# CITY OF IMPERIAL

## ADDENDUM NO. 4

### TO THE CONTRACT DOCUMENTS AND SPECIFICATIONS FOR THE CITY OF IMPERIAL BID NO. 2014-04

#### STREET IMPROVEMENT PROJECT ASPHALT RUBBER COMPOSITE LAYER OVERLAY ON DESIGNATED STREETS

### ECCENTRIC SEWER MANHOLE DETAIL

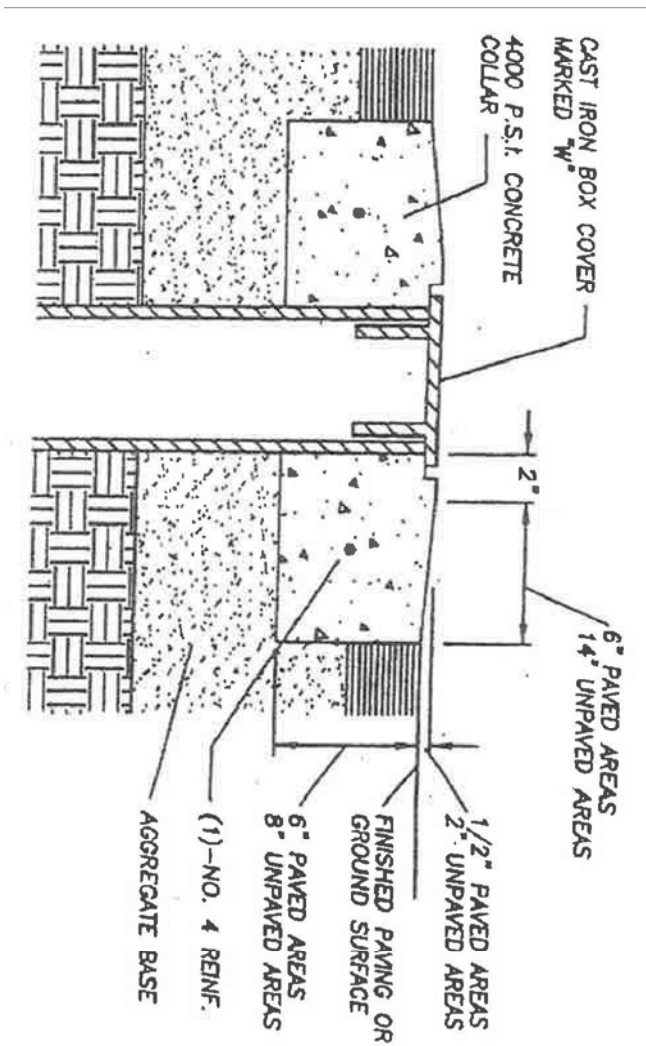
**Question:** In reference to the Project listed above bidding on 8/19/14, we would like to have the Standard drawing for the adjusting of utilities. That is, the Standard Drawing for adjusting Water Valves and Manholes (Bid Item No. 11 & Bid Item No. 12).

**Question:** What If a manhole frame and cover is broken, does the City have replacements?

**Answer:** Yes. See attachment details for "Typical Valve Box Concrete Collar" and "Eccentric Sewer Manhole Detail".

**Answer:** Concrete collars for water valves and manhole frame/cover shall be 4000 PSI concrete. See details.

M.H FRAME AND COVER SHALL BE ALHAMBRA FOUNDRY A-1497 OR AN APPROVED EQUAL MARKED "S" AND A 3/4" PICK HOLE

INSTALL A 1'-0" WIDE 1'-0" DEEP CONCRETE RING CIRCUMFERENTIALLY AROUND THE MANHOLE FRAME. PLACE THE CONC. RING FLUSH WITH PAVEMENT 4,000 PSI COMP. STRENGTH

<b>TYPICAL VALVE BOX CONCRETE COLLAR</b>		SHEET: OF: <b>1</b>
IN THE CITY OF IMPERIAL, CALIFORNIA	DATE: 07/21/14	BY: A.A.
STD. DET. NO. 61

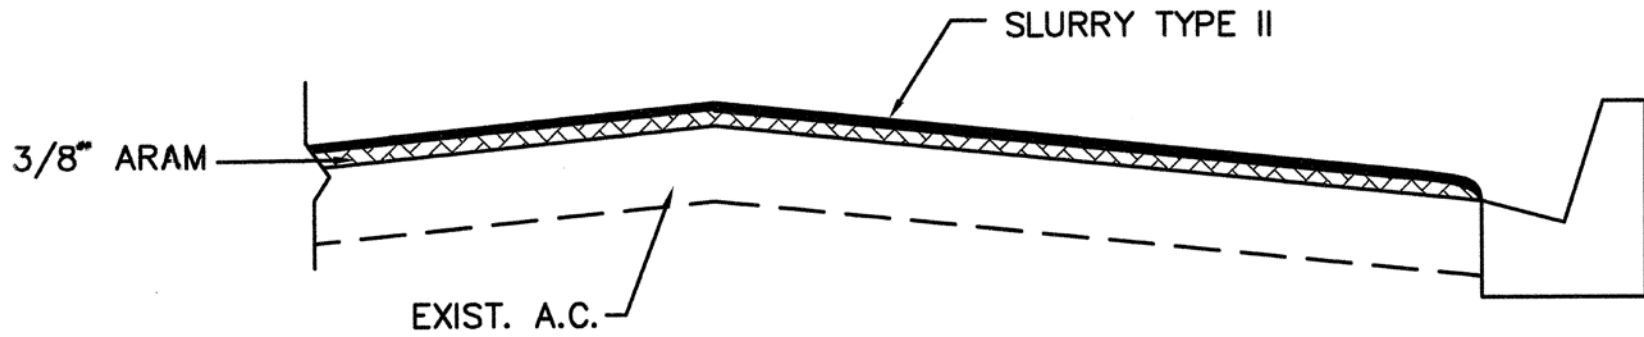
**Question:** What type of concrete is it specified. Will our crew be allowed to mix it onsite?

CUL-DE-SAC BULB PAVEMENT SECTION

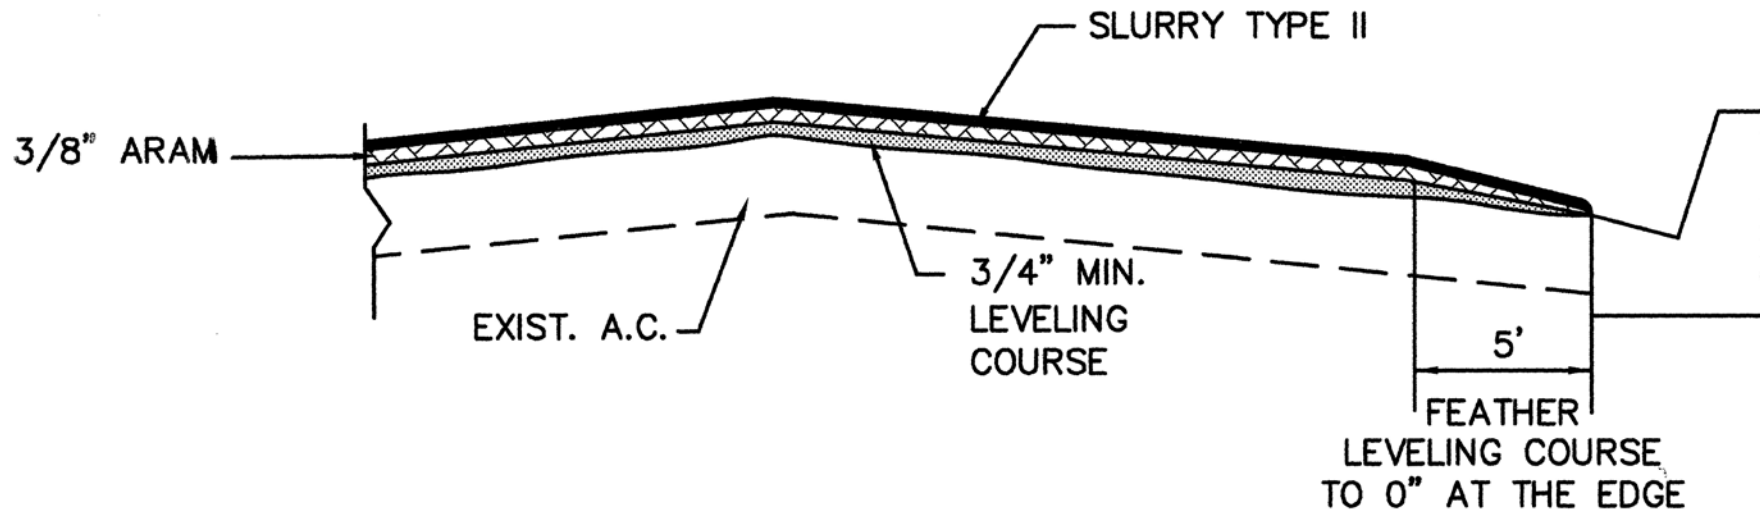
**Question:** Also, the cul-de-sac bulbs, are they to be paved with 1.5" of conventional hot mix?

**Answer:** Yes. Conventional PG 64-16 hot mix shall be utilized as illustrated on detail sheet 4 of 10. See attachment.

## SYSTEM 3 STOP POINT

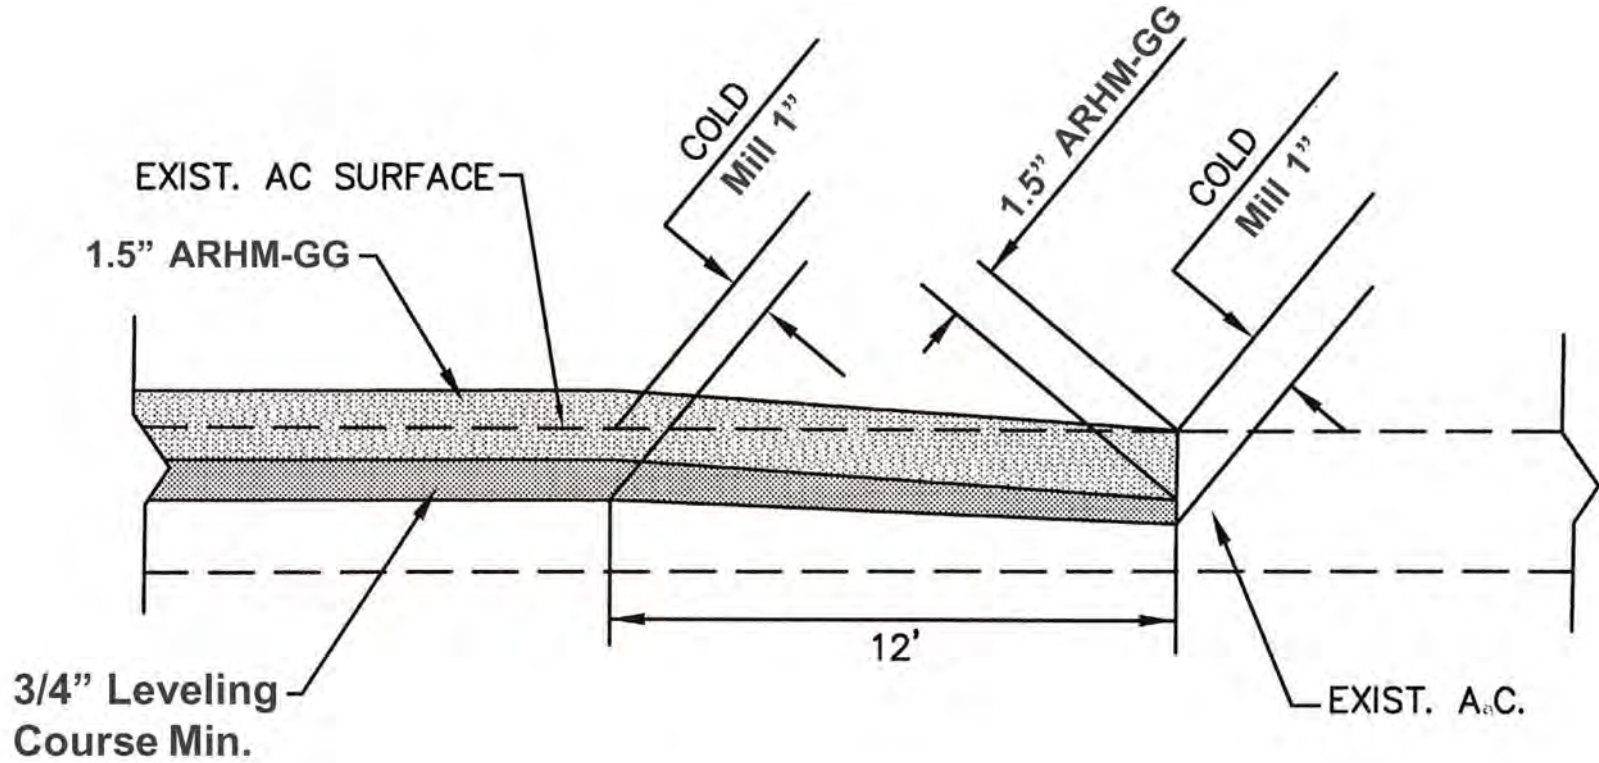
**Question:** Are the 6 stop points, bid item 5, to be paved with 1.5" of Asphalt-Rubber Hot Mix?

**Answer:** Yes. Asphalt Rubber Hot Mix-Gap Graded (ARHM-GG) shall be use as illustrated on detail sheet 6 of 10. See attachment.
